**DEPARTMENT of ENVIRONMENT
and NATURAL RESOURCES**

Re: Wharf Resources Large Scale Mine Permit Application

Staff review continues on Wharf Resources' permit application for the Wharf Expansion Project which was submitted February 18, 2011 and supplemental information submitted July 5, 6, 7, and 14, 2011. Based on this review, the department has generated the following technical comments:

June 2011 Application Revision 1.0

**Suggested Revision
to Permit Boundary**

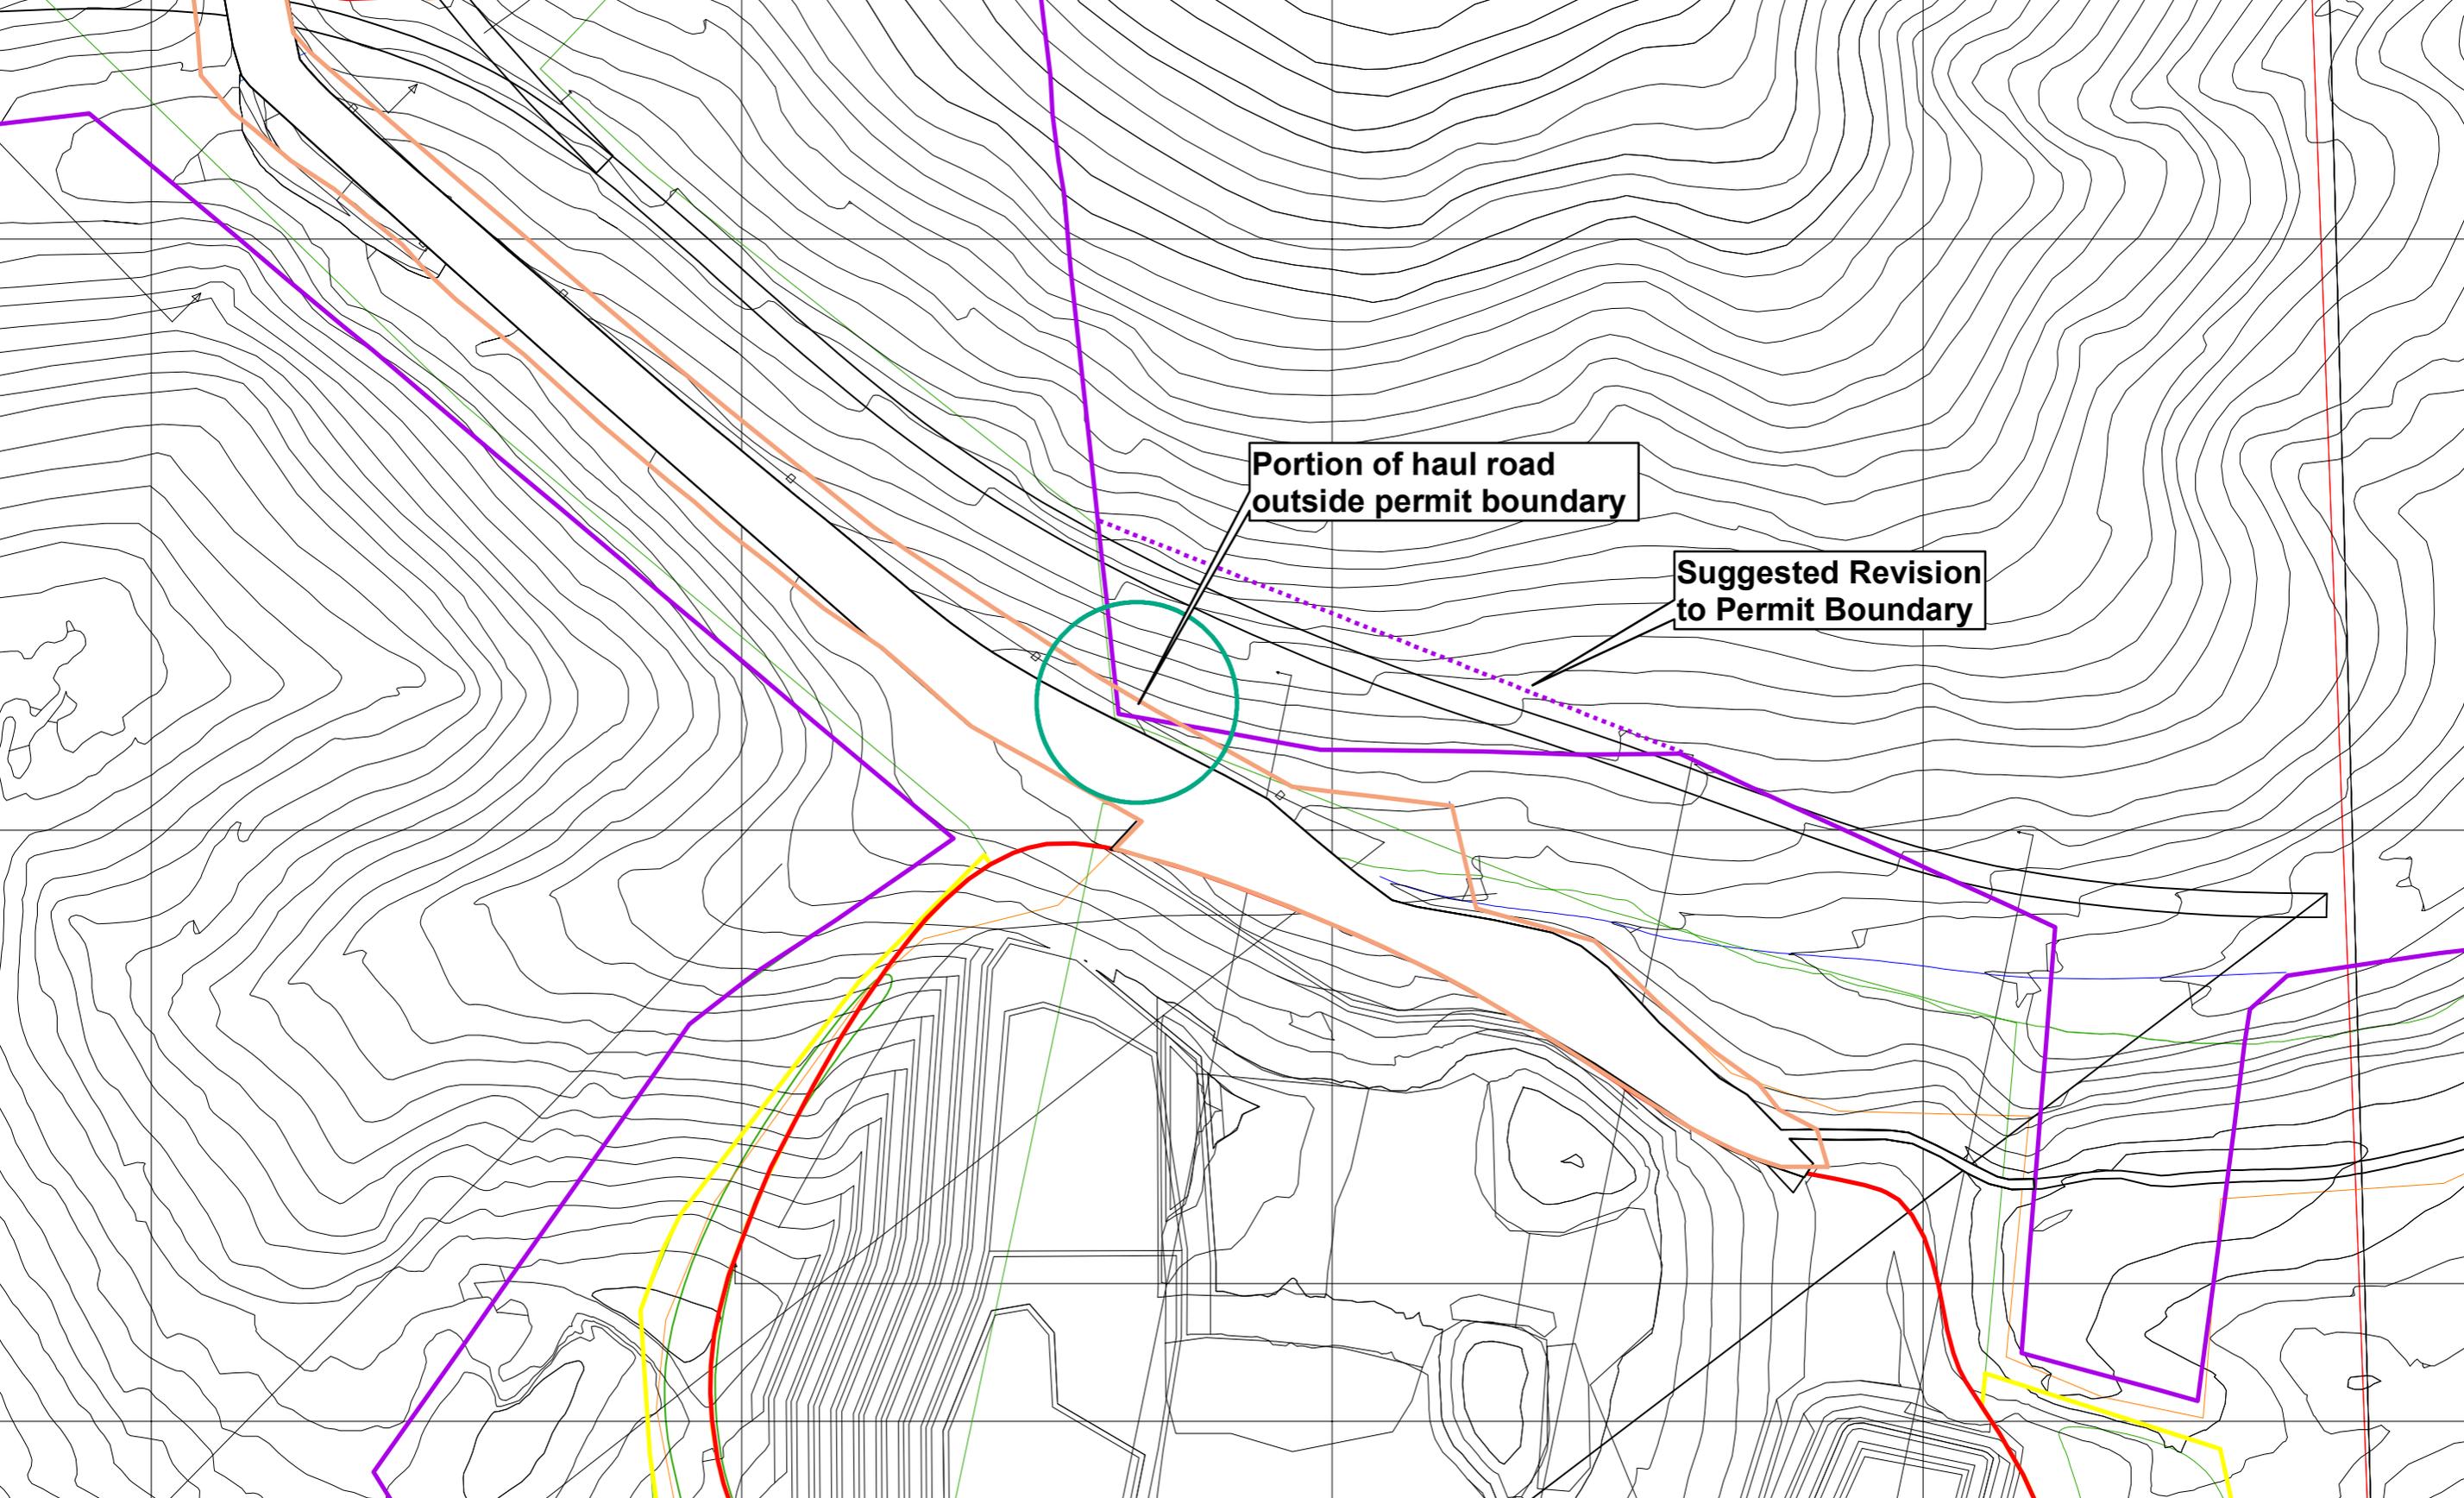
20. Exhibit 7 – Cross section K-K' still shows a small portion of the Precambrian formation being mined. Is this cross-section correct?
21. Exhibit 21 – A small portion of the fence line around the haul road is outside the proposed expansion permit boundary (see attached map). Wharf may want to consider moving the permit boundary as shown on the attached map so that the fencing disturbance is inside the permit boundary and Wharf has some room to move the haul road if necessary.

**Portion of haul road
outside permit boundary**

DNR TECHNICAL COMMENTS--FIGURE 1

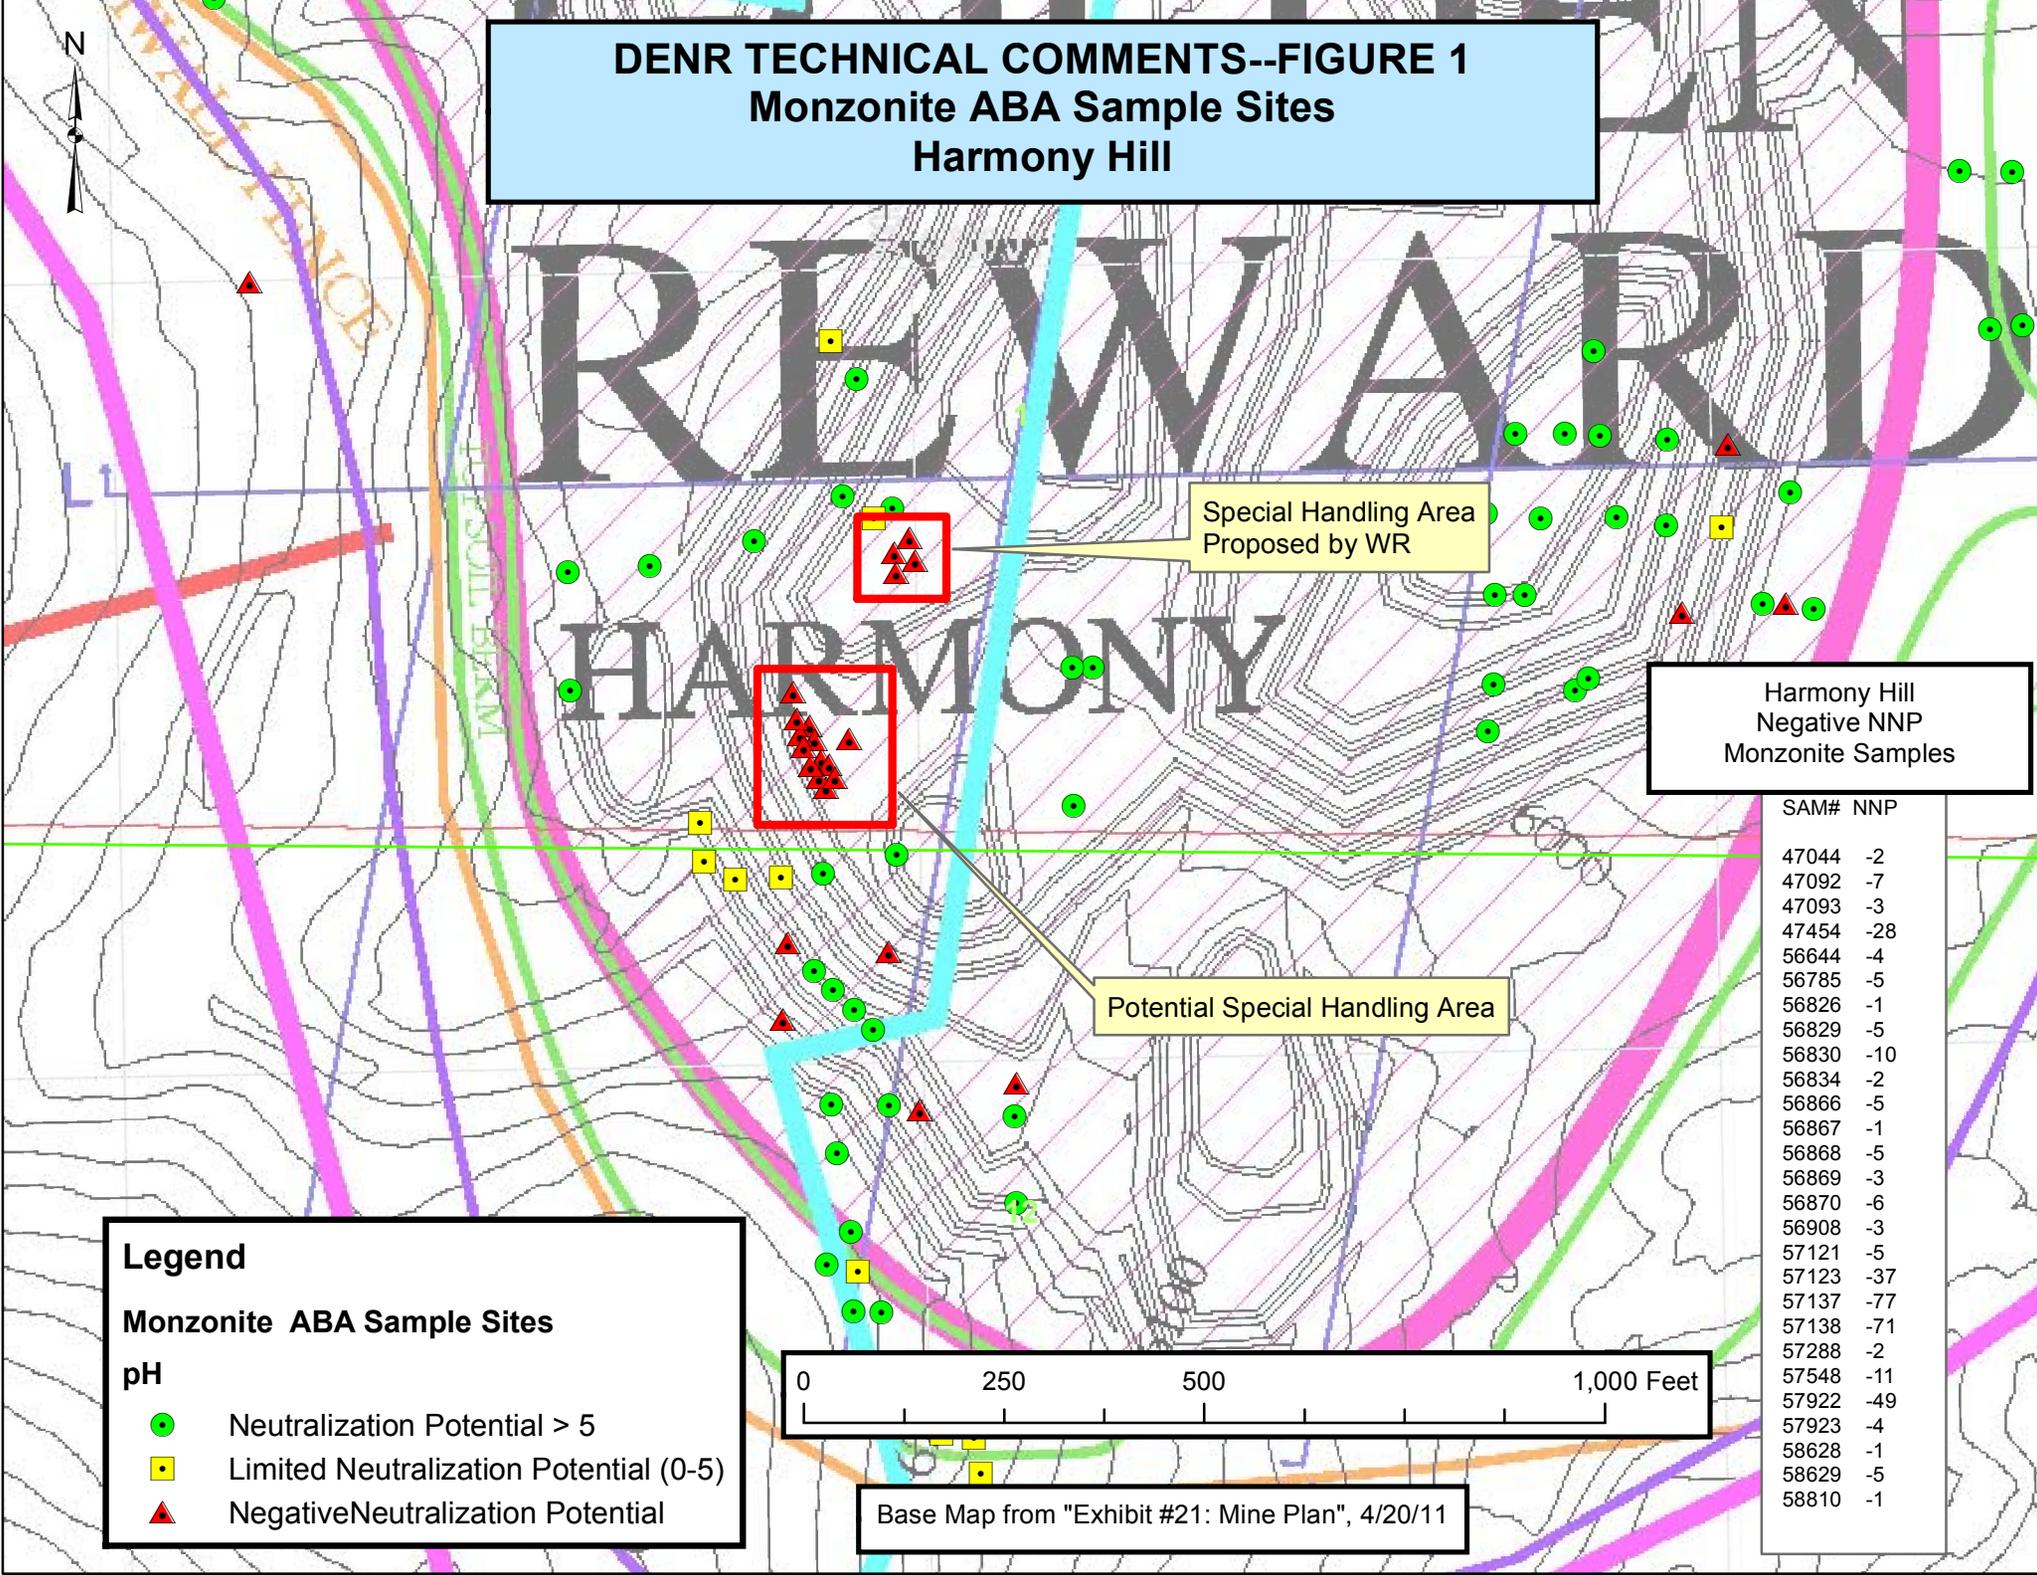
2. Section 3.1.3.1.7, page 29 - In this section, Wharf discusses ARD potential at Harmony Hill, the saddle between Green Mountain and Bald Mountain (east end of Green Mountain Pit), and the Flossie area. Wharf needs to clarify ABA sampling results by providing a relatively large-scale map of each of these three areas. The maps must show

precise test hole locations (i.e., use a labeled point to depict hole sites, not just the hole ID#), and delineate any Special Handling Material (SHM) identified at each of the three sites.

Also, Wharf states, “The SHM #2 is located in the Harmony Highwall and is comprised of four samples that indicate potential for ARD. SHM #2 has a projected size of less than 10,000 tons and consists of four samples that are surrounded by adjacent material so that it can be mined and blended to ensure a 3:1 NP:AP ratio and 20 NNP value.” In addition to the four potentially acid generating samples Wharf classified as “SHM #2”, there appears to be a second cluster of low NNP-value samples approximately 200 feet southwest of SHM#2 (see enclosed *Figure 1 Monzonite ABA Sample Sites Harmony Hill*). This potentially acid generating area needs to be addressed in the application narrative. Also, Wharf needs to address whether this second cluster represents a discrete pod of acid generating rock, or if the two clusters comprise a larger area of potentially acid generating monzonite at Harmony Hill.
